Further Information requested for Forest Fest 2023

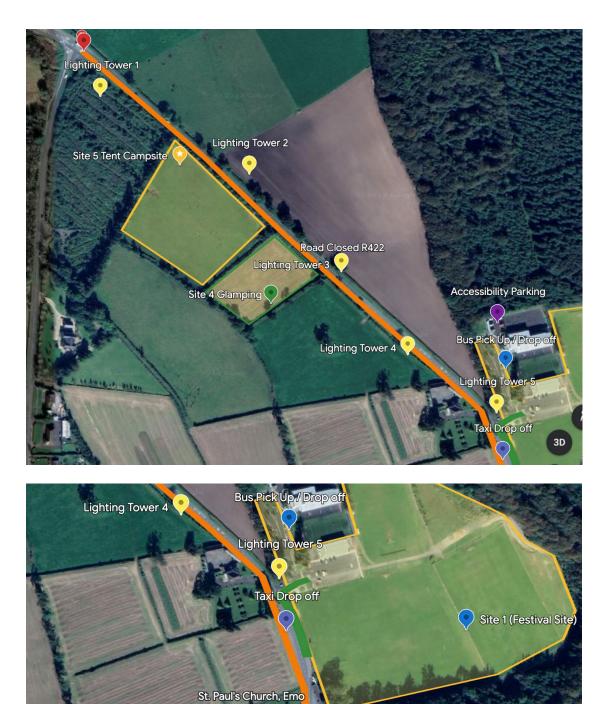
4. <u>The proposed Emergency Route is the main access point to Emo</u> <u>Court. It is not clear how visitors to Emo Court will access this amenity</u> <u>or how this will be managed in terms of traffic management.</u>

6. Details of lighting are required.

The OPW have confirmed, in relation to Emo Court that all visitors will be directed to the rear entrance on the Port Arlington side so use of the entrance and route in Emowill be confined to Emergency Route traffic, The organisers will provide signage to direct visitors to that entrance

Lighting in the arena and campsites/parking is indicated on the revised drawings attached, There are 8 lighting towers allocated for use in the village. These will be positioned in liaison with An Garda Siochana as was done last year, Proposed locations are shown below
